DOE/EIS-0474-SA-1
SUPPLEMENT ANALYSIS
SOUTHLINE TRANSMISSION LINE PROJECT ENVIRONMENTAL IMPACT STATEMENT

INTRODUCTION

Map 1 – Vail Lateral (Route Group 4, segment U4)

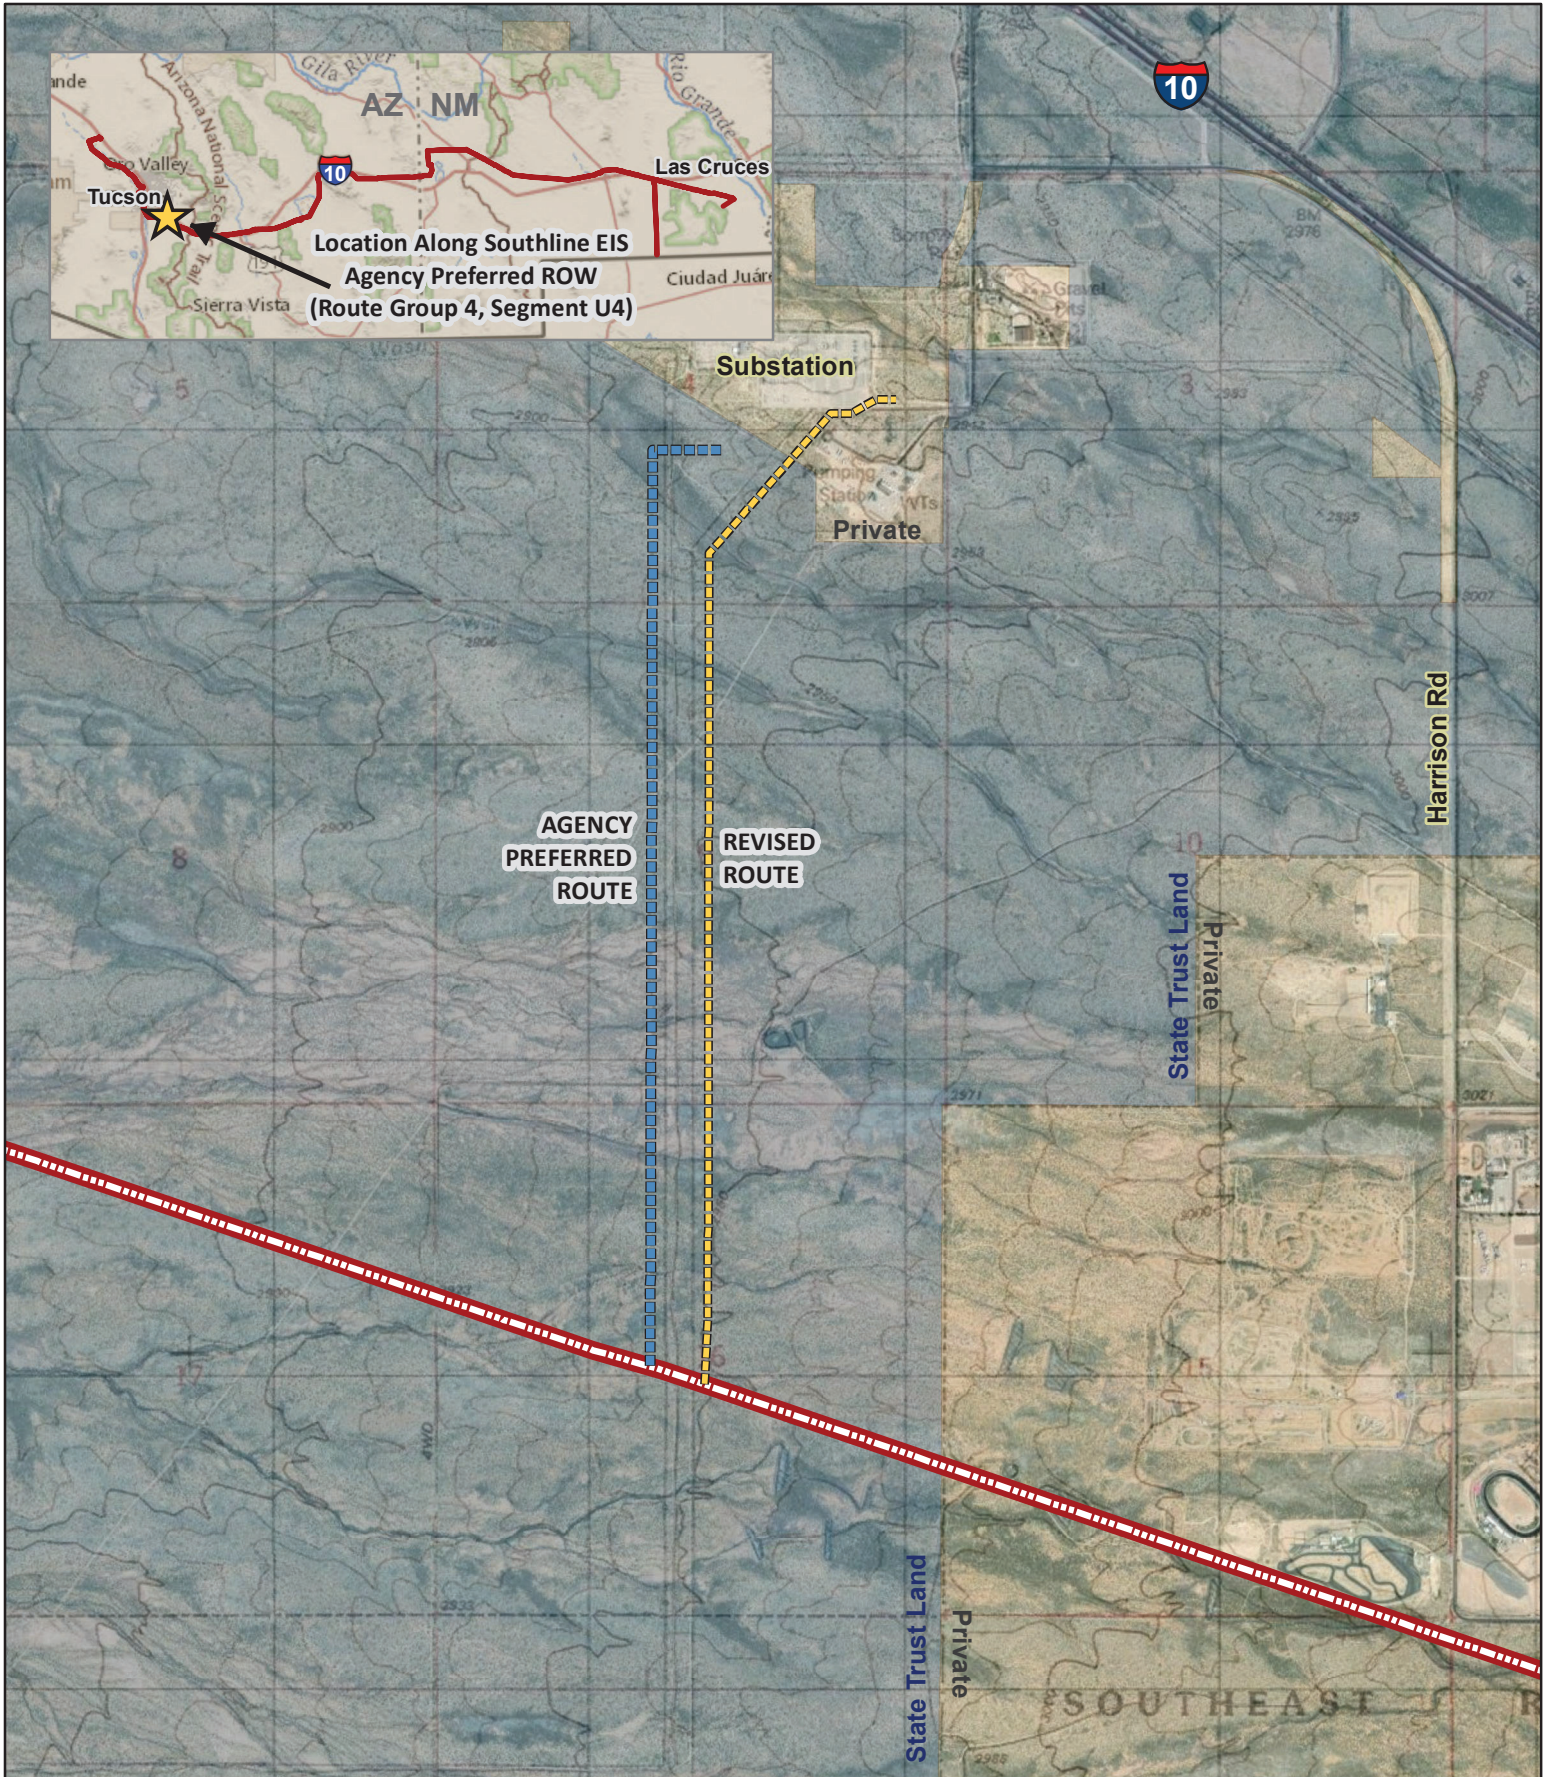
The Agency Preferred Alternative from the SL EIS included a connection route from the existing transmission line running due north for 2 miles and connecting to the Vail Substation on its west side. Because of a conflict with an existing Kinder-Morgan natural gas facility, the Vail Lateral was moved east 600 feet, and adjusted to extend 1.66 miles due north from the existing transmission line before angling northeast for 2,000 feet. The route then continues east 240 feet along the southern boundary of the existing substation, before angling northeast 310 feet to its proposed terminus and the final location of the Vail Substation 230-kV bay expansion.

This refined route is 317 feet longer than the original and remains on Arizona State lands, except for 190-feet of the 2,000-foot run, described above, which crosses the adjacent Kinder-Morgan property at the northwest corner of the parcel, away from the previous conflict. The refined route has less impact on public land use as the ROW would abut an existing Arizona Electric Power Cooperative transmission line to the southwest corner of Vail Substation. Impacts of this change on other resources evaluated would be negligible.

Map 2 – Tucson Airport Reroute (Route Group 4, segment U3aPC)

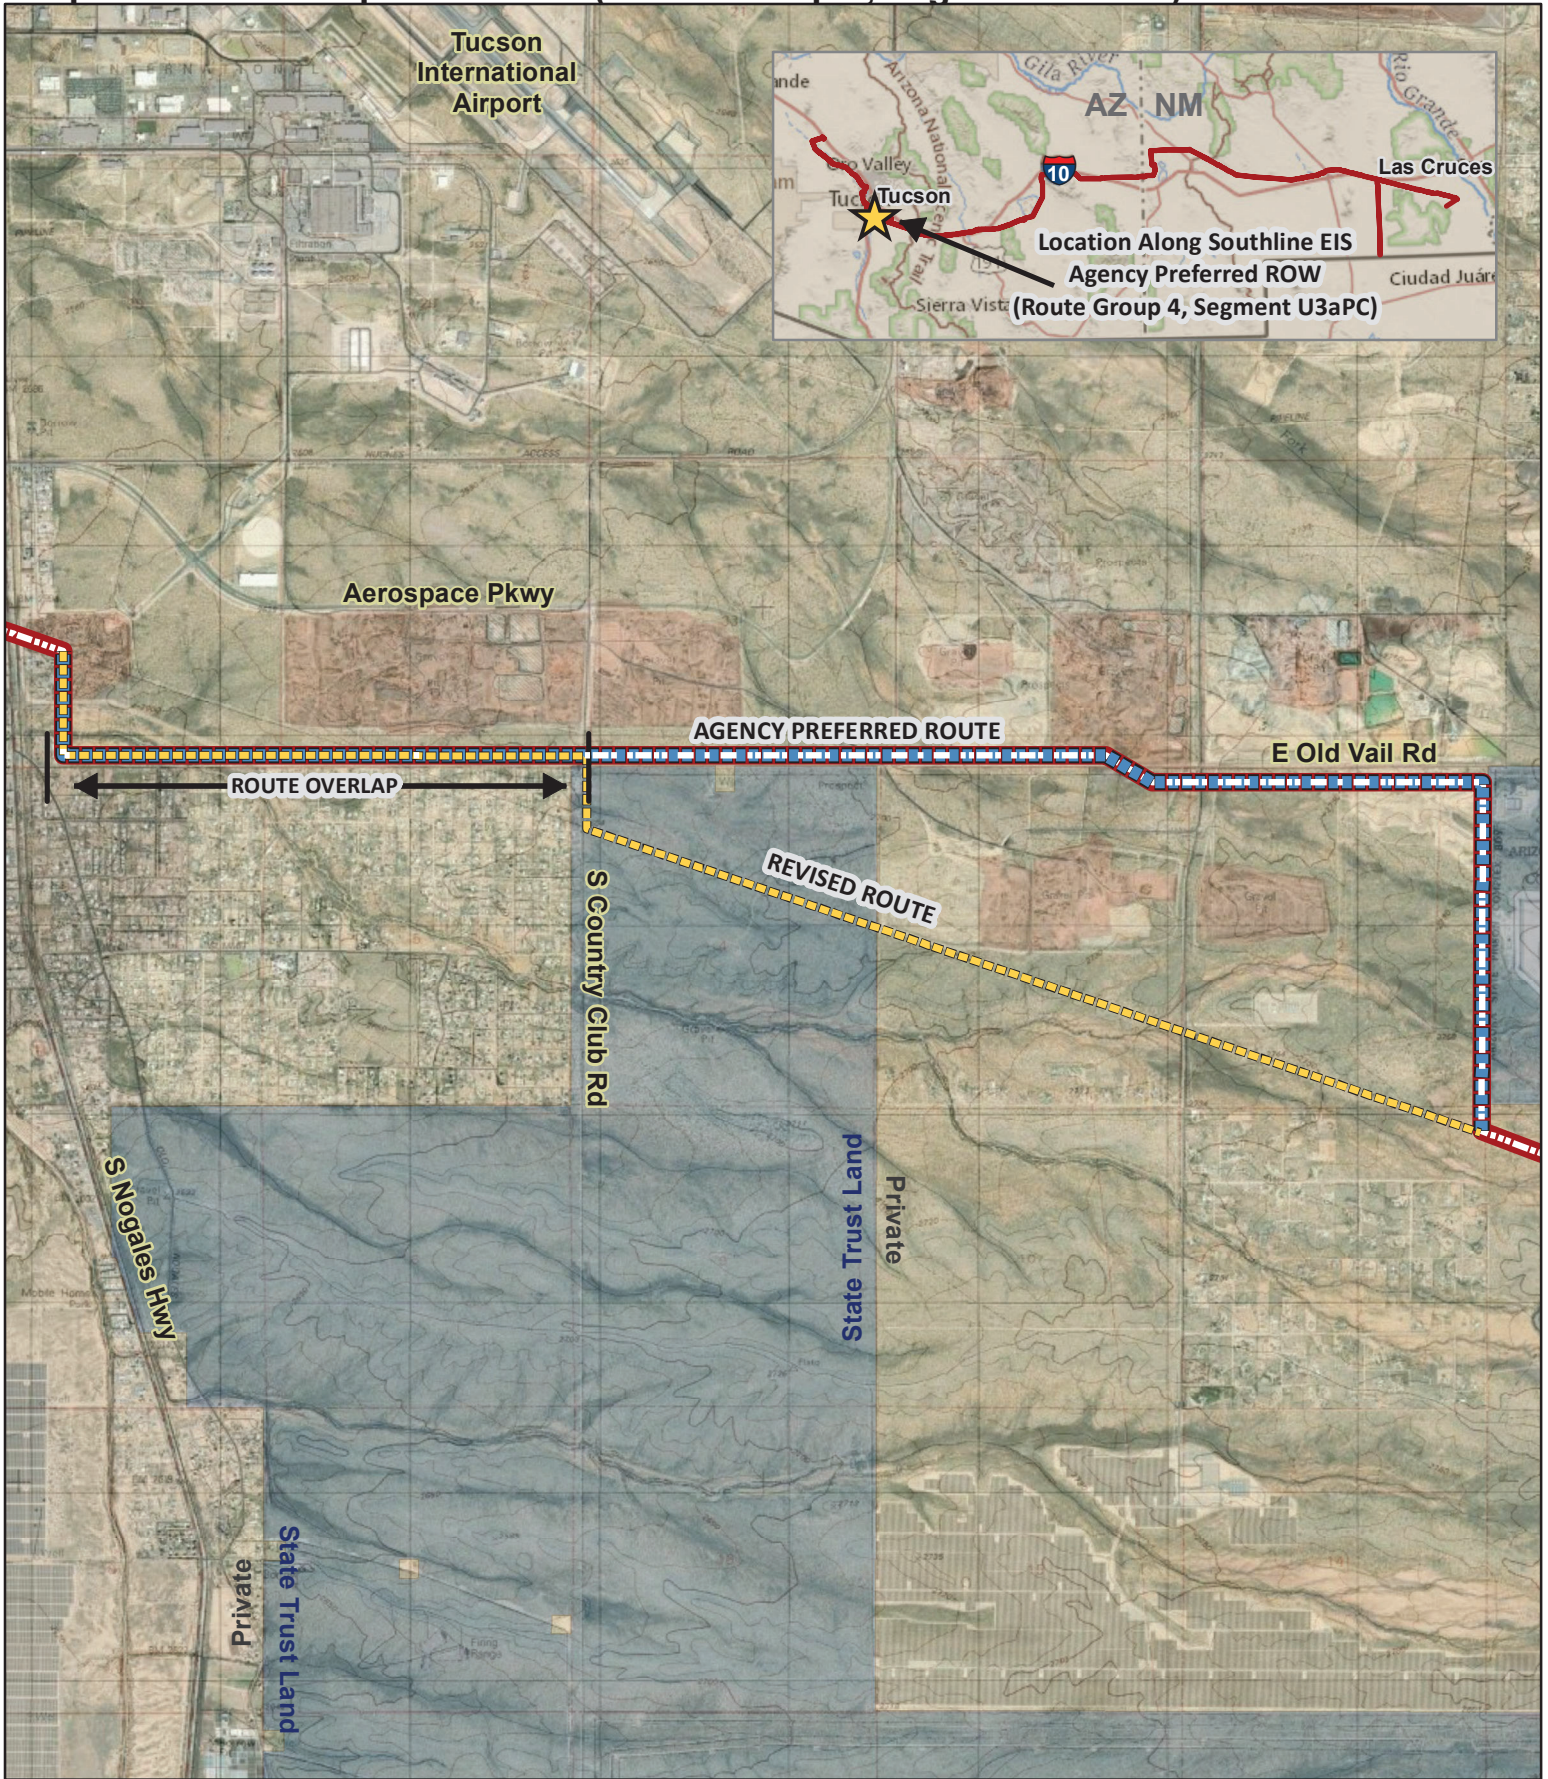
The Agency Preferred Alternative incorporated a transmission line reroute south of the Tucson International Airport. The route evaluated in the SL EIS crosses a large parcel of Pima County and Tucson Airport Authority property proposed for development. Subsequent to the ROD, the reroute was moved to parallel the southern boundary of these parcels, on the north side of East Old Vail Road. The total length of this reroute was 6.65 miles, which replaced 5.11 miles of existing ROW.

Since the SL EIS was completed, TEP constructed a new switchyard south of the airport reroute, north of the existing alignment, with several transmission and distribution lines approaching it from the north. These lines would need to be crossed by the new transmission line, requiring taller double-circuit structures to maintain required clearances.

Coordination with the Federal Aviation Administration (FAA) resulted in the determination that constructing the new line along the planned reroute was not a viable option as the structures would be too tall and would pose an aviation hazard. Accordingly, the reroute was adjusted to follow the westernmost portion of the airport reroute only to a point just east of the Summit development, then south along South Country Club Road to the existing ROW, replacing 4.86 miles of the 6.65-mile-long airport reroute.

Adverse effects to natural resources from this reroute refinement would be reduced by staying on the existing ROW as compared to the airport reroute described in the SL EIS. The area is previously disturbed and has existing maintenance access. The updated route utilizes 3.13 miles of the existing ROW, replaces 4.86 miles of new construction, and would be 1.73 miles shorter than the reroute described in the SL EIS. Impacts to resources from this reroute refinement would be negligible.
